1. Type of Well JUL 28 2014				WBDU NM120042X				
🔽 Oil Well 🚺 Gas V	Well Other			 Well Name and No. West Blinebry Drinka 	rd Unit (WBDU) #105 (37346)

WBDU 105 (API: 30-025-40480) Proposed Workover Procedure

Complete and Fracture Stimulate the Blinebry

East Blinebry Drinkard Unit 105 30-025-40480 Apache Corporation July 21, 2014 Conditions of Approval

Proposed Wellbore Diagram

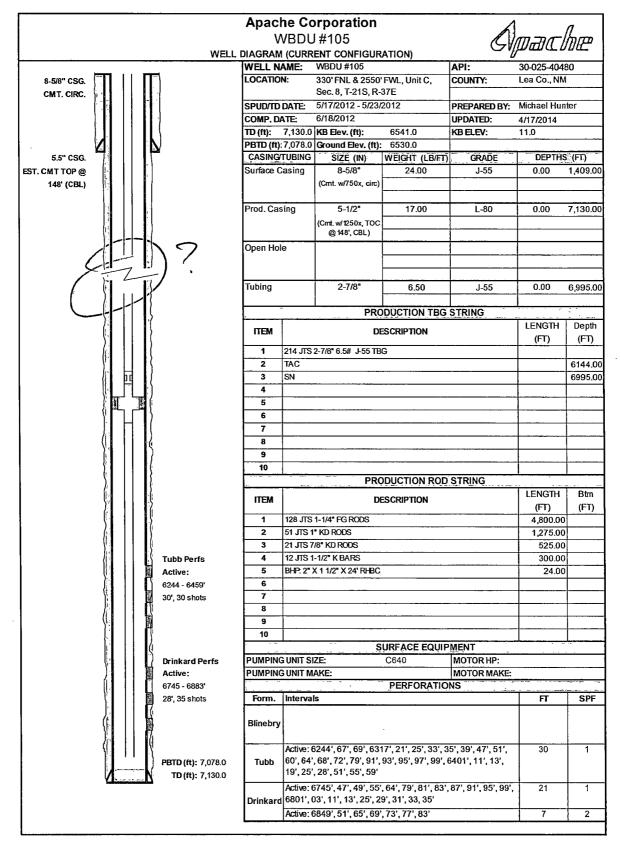
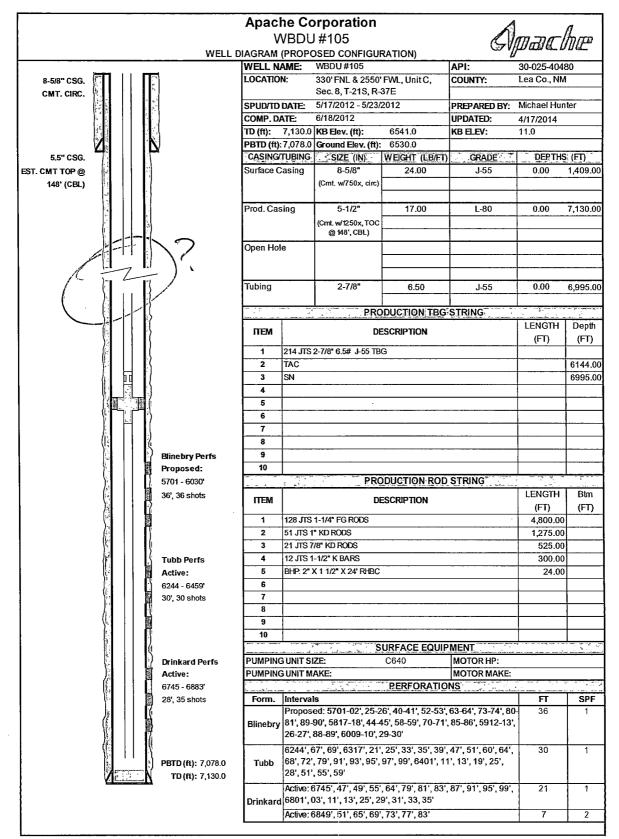
- 1. Must conduct a casing integrity test before any perforating or fracturing can be done. Submit results to BLM. The CIT is to be performed on the production casing to max treating pressure. Contact the BLM if test fails.

- 8. Subsequent sundry required detailing work done. Operator to include well bore schematic of current well condition when work is complete.
